TO: Greenheck Business Partners  
 FROM: Andy Jackson  
 Product Manager, Louvers  
 DATE: April 11, 2022  
 SUBJECT: Reduced Actuator Quantity-EAD-632W Adjustable Louver

*Figure 3*

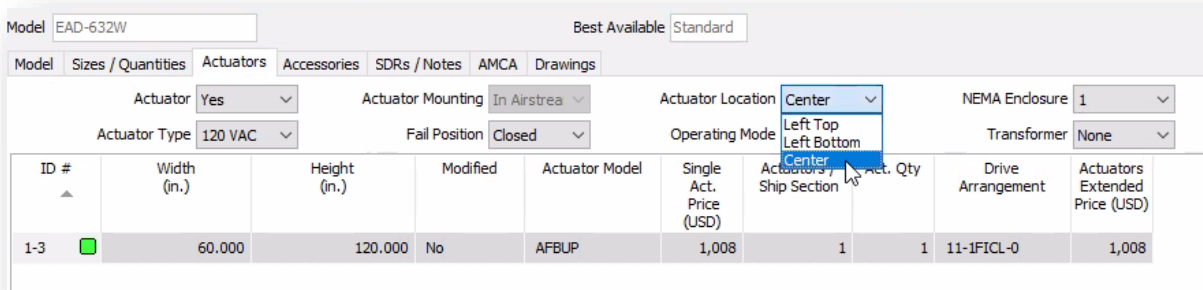
We intend to offer more line-item configurability as opposed to mark level configurability in future CAPS releases. Until such time, EAD-632W selections with heights 96 - 120 inches should be configured on a stand-alone mark so that the option for Actuator Location Center may be selected (*Figure 2, 3*). Actuator Location Center is only available when heights are 96 - 120 inches. If you have lines less than 96 inches with Actuator Location Center selected, you will notice a red box on the ID level indicating no availability for the selection (*Figure 4*). Move these lines to a new mark, with either Actuator Location Top Left or Actuator Location Bottom Left selected (*Figure 5*).
